**RE: Slim Chicken
8240 Montgomery Blvd NE
Grading and Drainage Plans
Engineer's Stamp Date: 04/26/21
Hydrology File: G19D004E**

Based upon the information provided in your resubmittal received 04/26/2022, the Grading & Drainage Plan is **not** approved for Building Permit and for action by the DRB on Site Plan for Building Permit. The following comments need to be addressed for approval of the above referenced project:

RE: Slim Chicken
8240 Montgomery Blvd NE
Grading and Drainage Plans
Engineer's Stamp Date: 02/22/21
Hydrology File: G19D004E

**RE: SLIM CHICKEN
8240 MONTGOMERY BLVD NE
GRADING AND DRAINAGE PLANS**

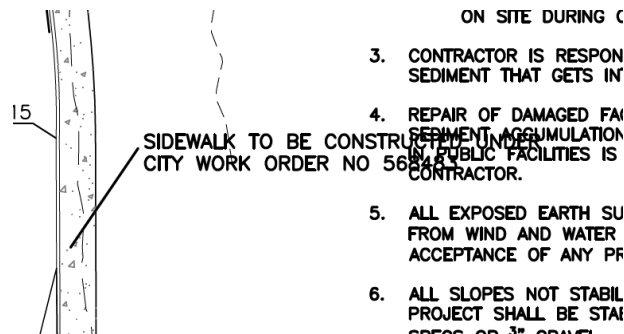
1. Please cleanup overlapping text.

Stamped Approved Interim Grading & Drainage

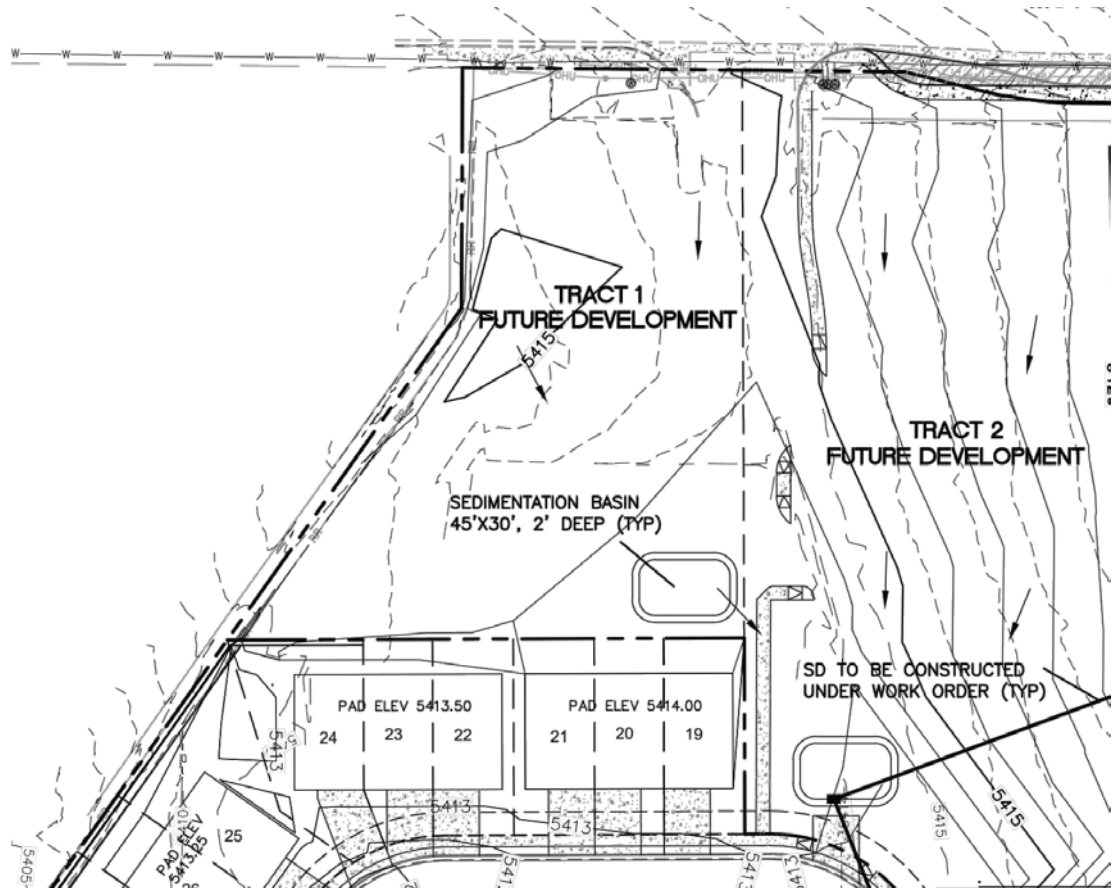
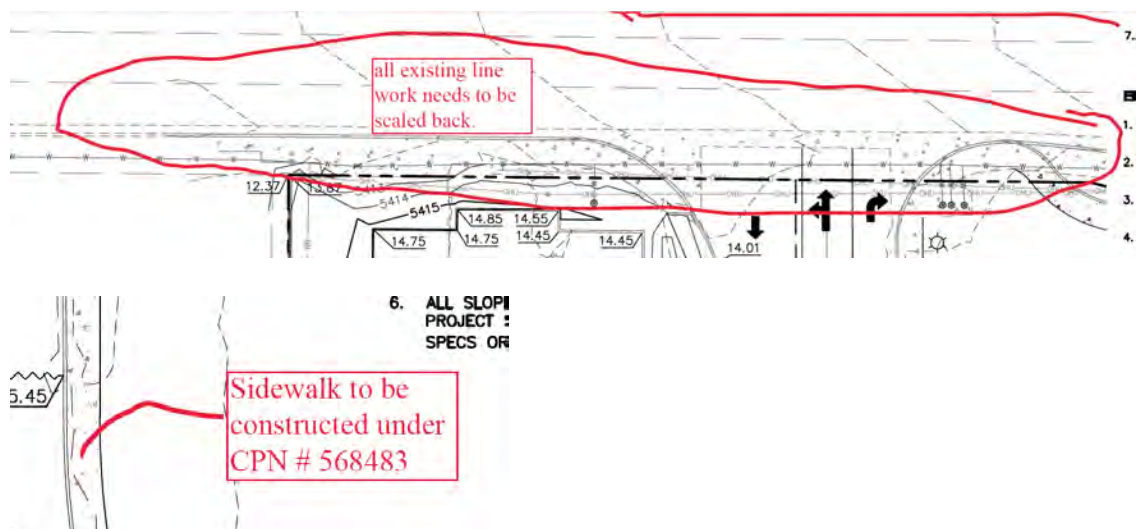
1. Please show the entire scope of the work to be done with this Permit. Below is the Approved Interim Grading & Drainage Plan for this Tract and entrance into Montgomery. Now show all the limits of the entrance. Most of this was demolished so that this site needs to build the entrance with curbs on both sides. The proposed sidewalk along the eastern part of the entrance needs to be labeled, "Sidewalk to be constructed un CPN # 568483. The existing line work within Montgomery needs to be shaded back so that the proposed work pops.

1. Please show the entire scope of the work to be done with this Permit. Below is the Approved Interim Grading & Drainage Plan for this Tract and entrance into Montgomery. Now show all the limits of the entrance. Most of this was demolished so that this site needs to build the entrance with curbs on both sides. The proposed sidewalk along the eastern part of the entrance needs to be labeled, "Sidewalk to be constructed un CPN # 568483. The existing line work within Montgomery needs to be shaded back so that the proposed work pops. **The entire scope of the work is shown on the plan. We added the note to the sidewalk and shaded back and dashed the existing items to remain.**

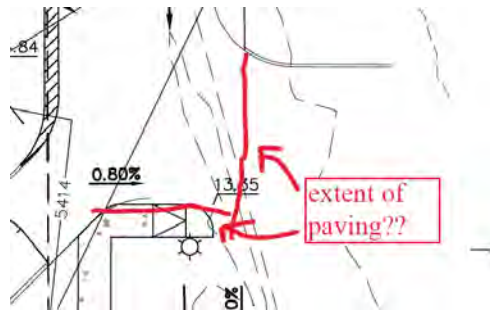
- Please add the flowline at the curb return at the Montgomery entrance.

2. Please add the flowline at the curb return at the Montgomery entrance. **A spot elevation was added at this location.**
3. Where is the extent of the paving along the southeast corner of the development? **We added a line and a note stating the limits of pavement for this project.**

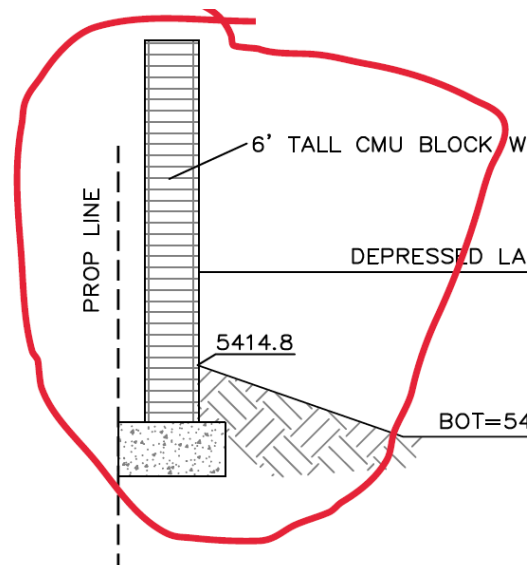
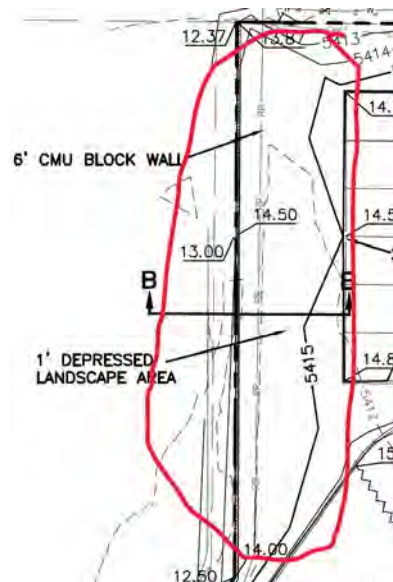
- Where is the extent of the paving along the southeast corner of the development?

- There is a missing CMU block wall on the plan that is shown in Section B-B.

4. There is a missing CMU block wall on the plan that is shown in Section B-B. **This layer was turned on and is now shown.**
5. Noticed that there is paving to be done on Tract B. It also appears that a majority of the drive (access road for the overall commercial) is on Tract B but should still be split between Tract A and Tract B. Please contact Transportation on this issue. Hydrology will need written letter from the Owner of Tract B authorizing the work to be done within Tract. This letter needs to be notarized. **This is a redevelopment of a shopping center that is owned by the same person. That owner still owns Tract "B" and these improvements are part of the overall redevelopment of the site.**

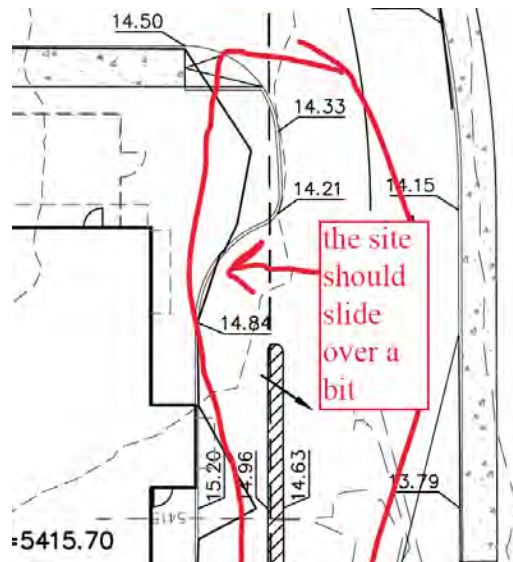
- Noticed that there is paving to be done on Tract B. It also appears that a majority of the drive (access road for the overall commercial) is on Tract B but should still be split between Tract A and Tract B. Please contact Transportation on this issue. Hydrology

will need written letter from the Owner of Tract B authorizing the work to be done within Tract. This letter needs to be notarized.

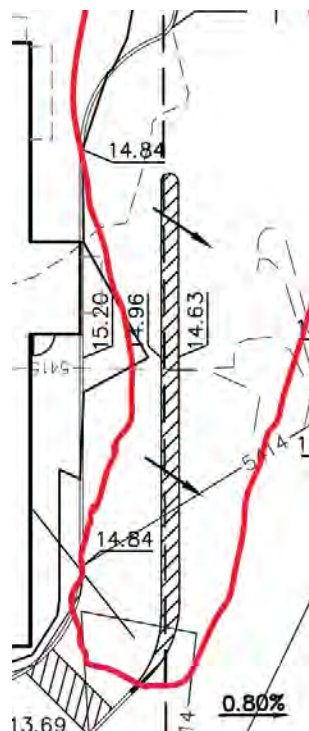
6. It appears that there is a lot of work on Tract B that should actually be on Tract A. This should slide over a little to make it work.

7. The separation between the drive-thru and the oncoming traffic from Montgomery should be a curb and not just stripped. Please contact Transportation for approval.

6. It appears that there is a lot of work on Tract B that should actually be on Tract A. This should slide over a little to make it work. **We shifted the curb to the west so it's all located on Tract A.**

7. The separation between the drive-thru and the oncoming traffic from Montgomery should be a curb and not just stripped. Please contact Transportation for approval. **We added a back to back mountable curb to provide this separation. A TCL will be submitted to the City for approval.**

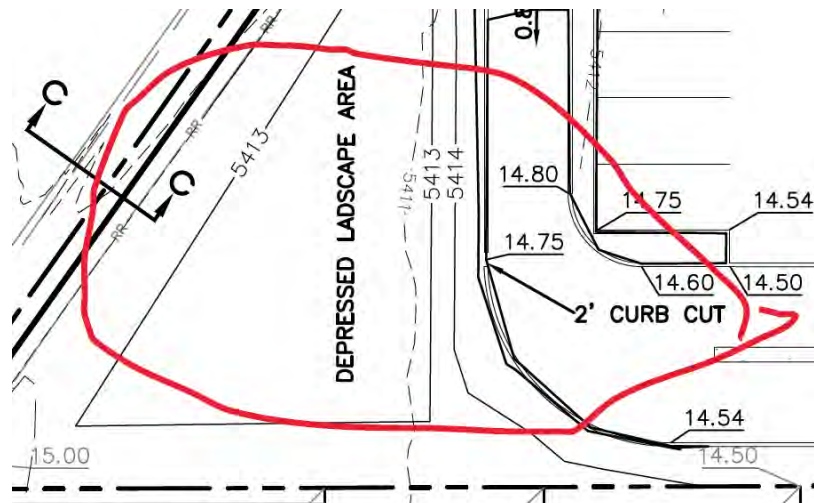
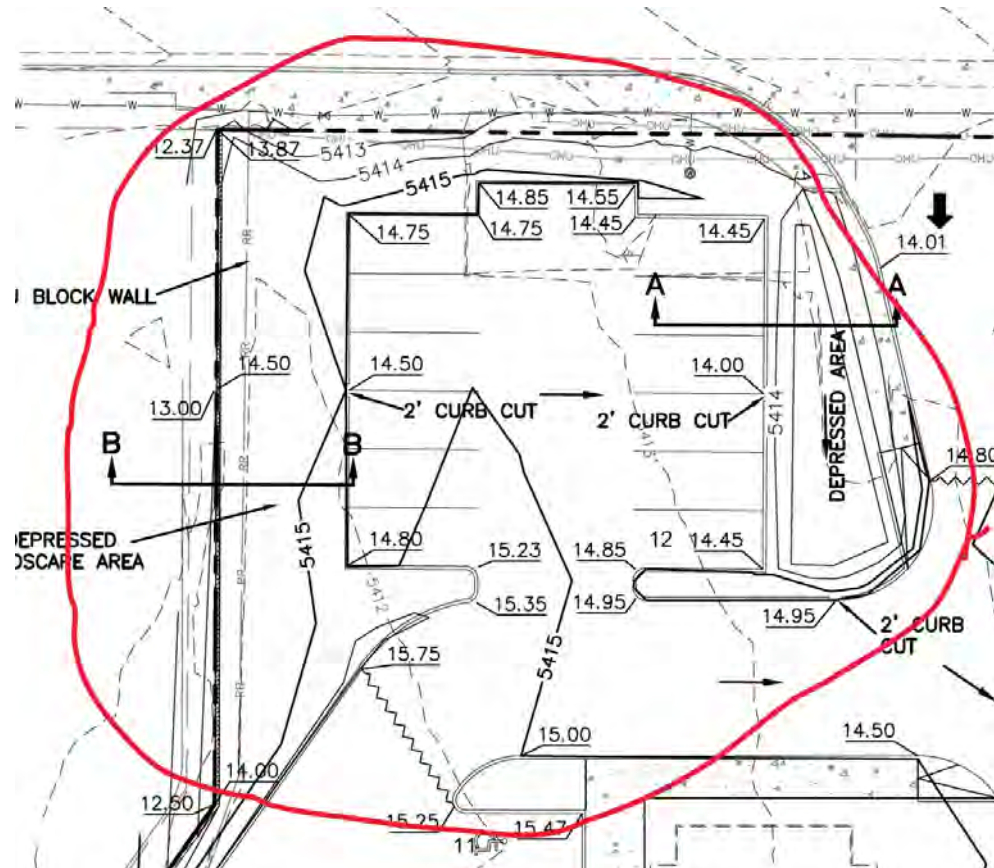
10. The entire Tract A needs to follow the approved overall development drainage management plan. See the wording below form that plan.

This site currently violates this approved plan with curb cuts into depressed landscaping areas that do not drain anywhere or drains into Montgomery Blvd which is not allowed.

10. The entire Tract A needs to follow the approved overall development drainage management plan. See the wording below form that plan.
This site currently violates this approved plan with curb cuts into depressed landscaping areas that do not drain anywhere or drains into Montgomery Blvd which is not allowed. **This Tract does follow the approved overall development drainage management plan. The depressed landscaped areas are to allow for passive water harvesting as stated in the narrative. These areas will be allowed to overflow through the curb openings and surface flow to the inlet indicated in the narrative. No flows drain to Montgomery.**

DRAWN BY
pm
DATE
4-26-22
DRAWING
2021089-GR
SHEET #
GR-1
JOB #
2021089

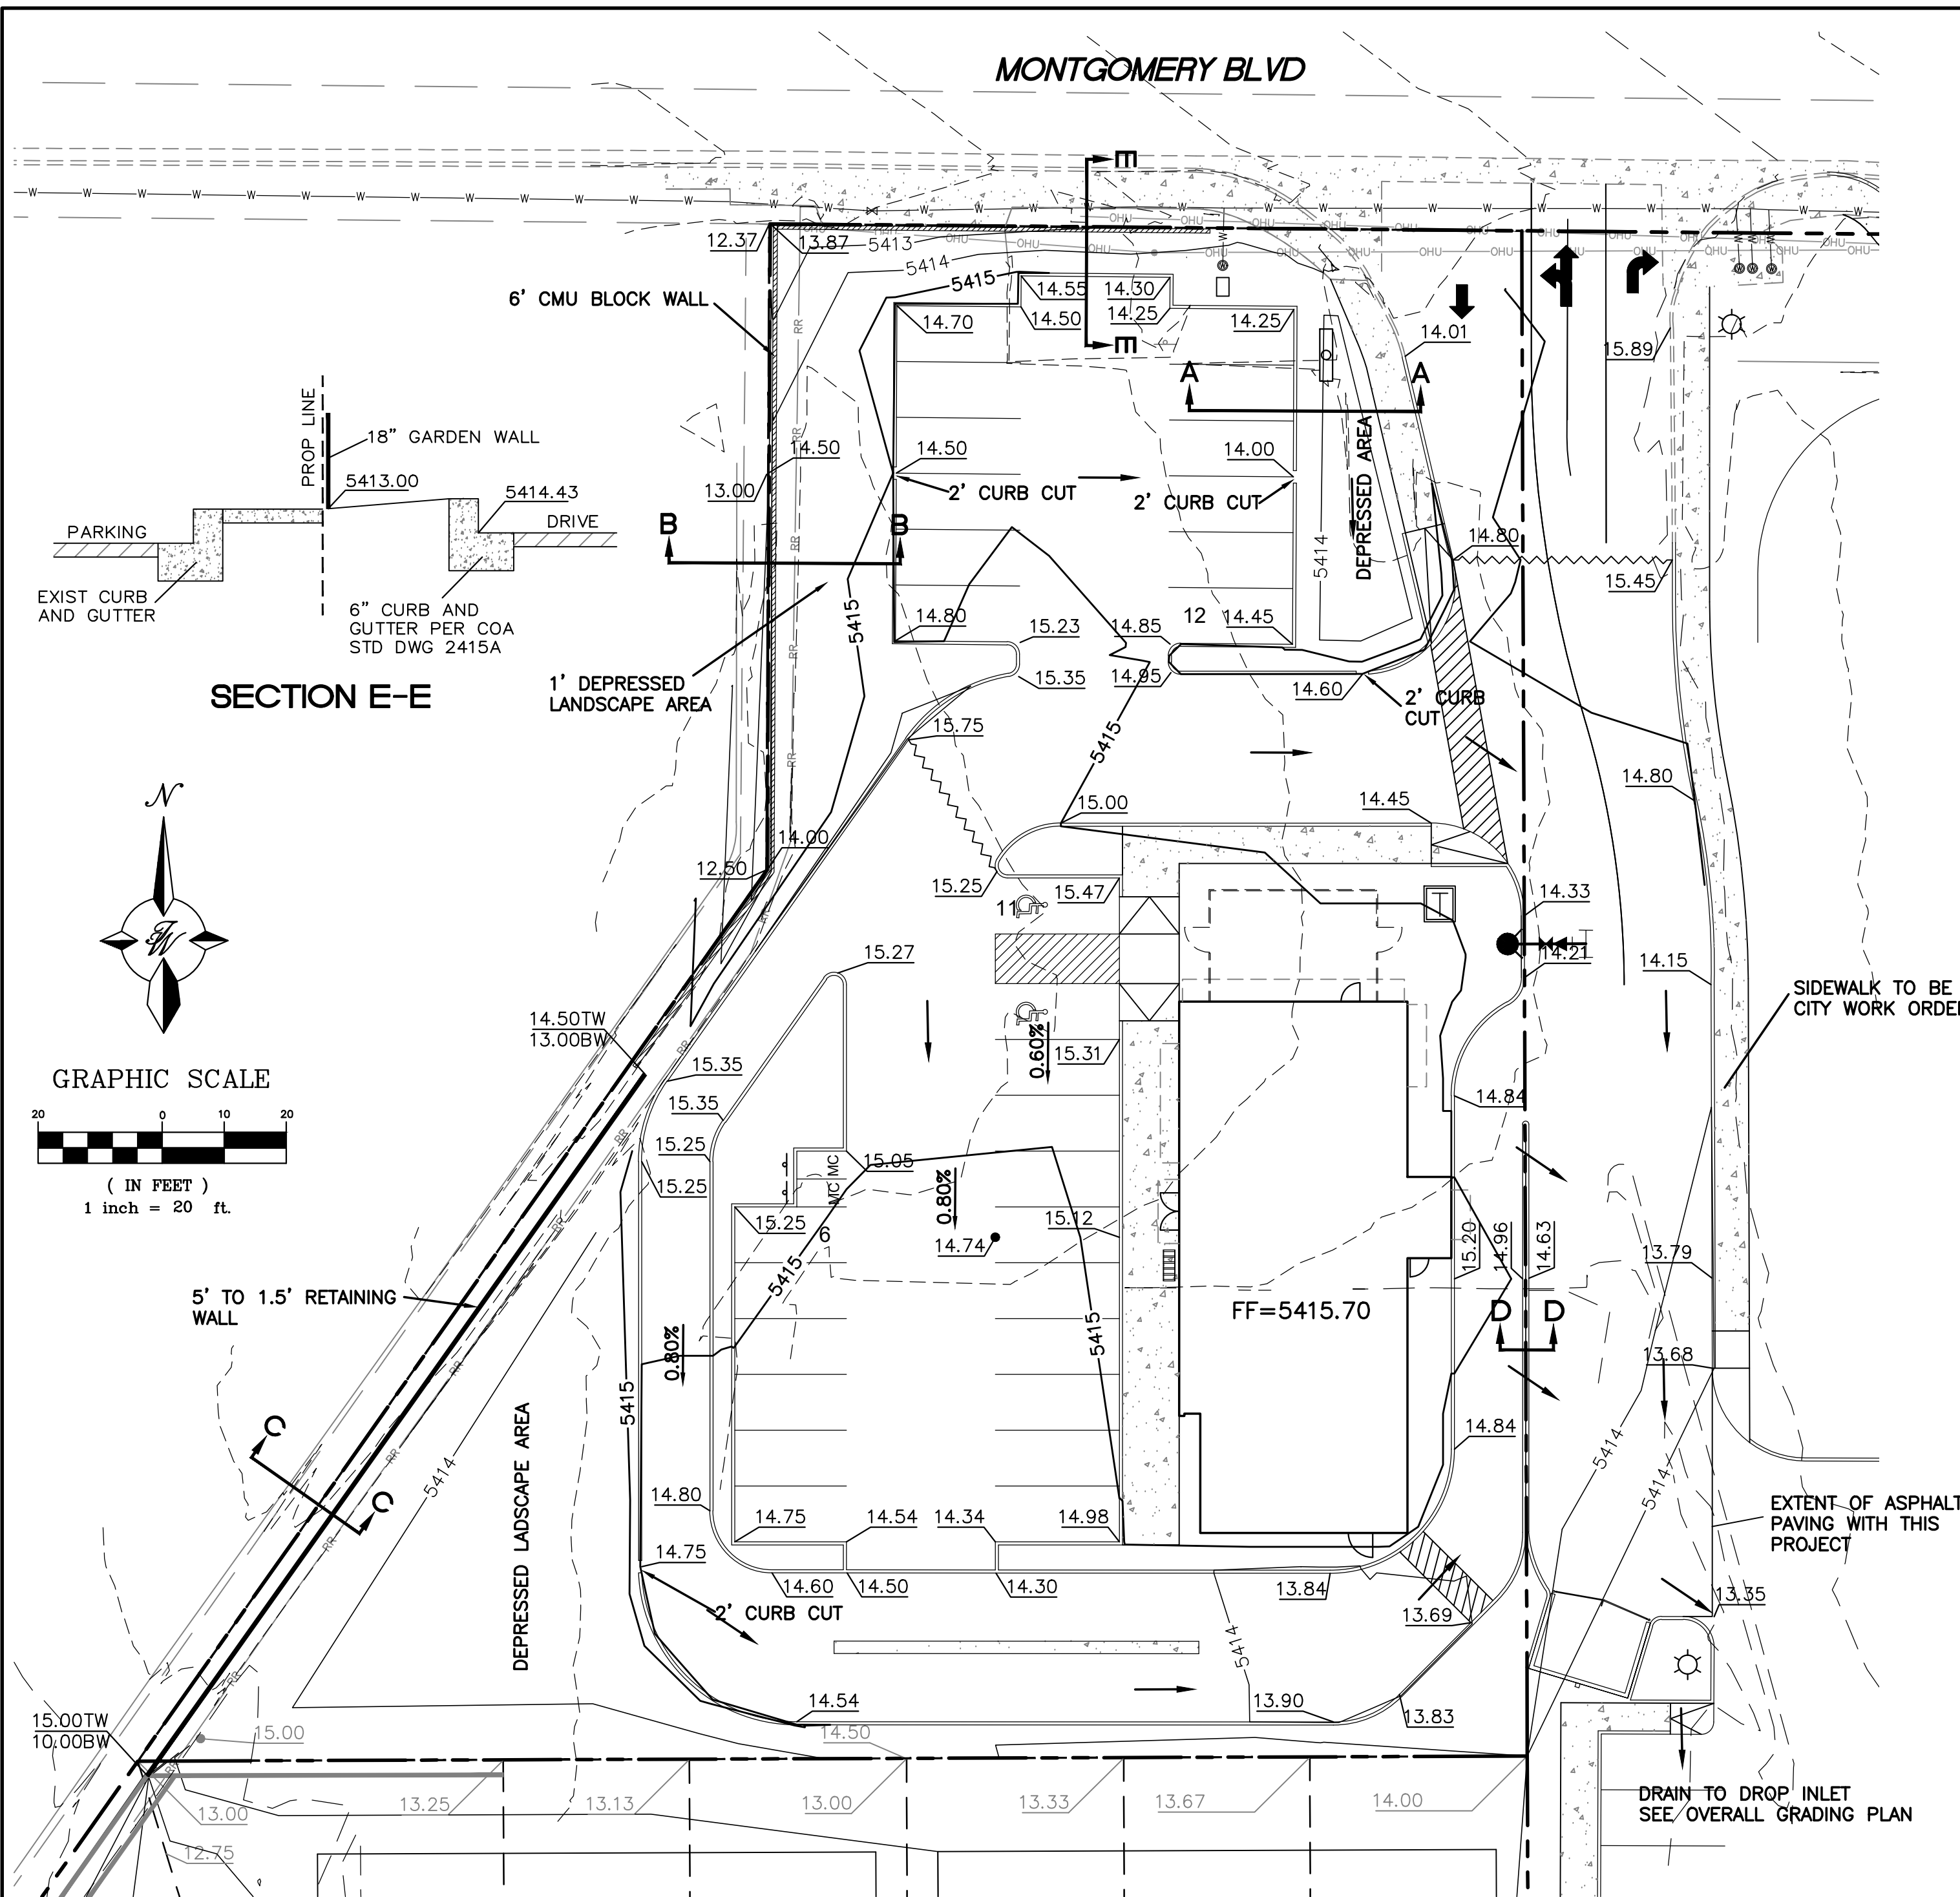
8. Please add both the existing conditions and the proposed condition calculations on the Grading & Drainage Plan. Reference to the overall development drainage manage plan is nice but the calculations are still needed on this sheet. The majority of Montgomery Blvd is not need, so the calculations can be place there.

9. Please provide the weir calculations, per DPM Article 6-16(A), for the curb cuts. A coefficient of 2.7 is typically used for the weir equation $Q = CLH^{2/3}$.

8. Please add both the existing conditions and the proposed condition calculations on the Grading & Drainage Plan. Reference to the overall development drainage manage plan is nice but the calculations are still needed on this sheet. The majority of Montgomery Blvd is not need, so the calculations can be place there. **This information was added to the plan.**

9. Please provide the weir calculations, per DPM Article 6-16(A), for the curb cuts. A coefficient of 2.7 is typically used for the weir equation $Q = CLH^{2/3}$. **This information was added to the plan.**
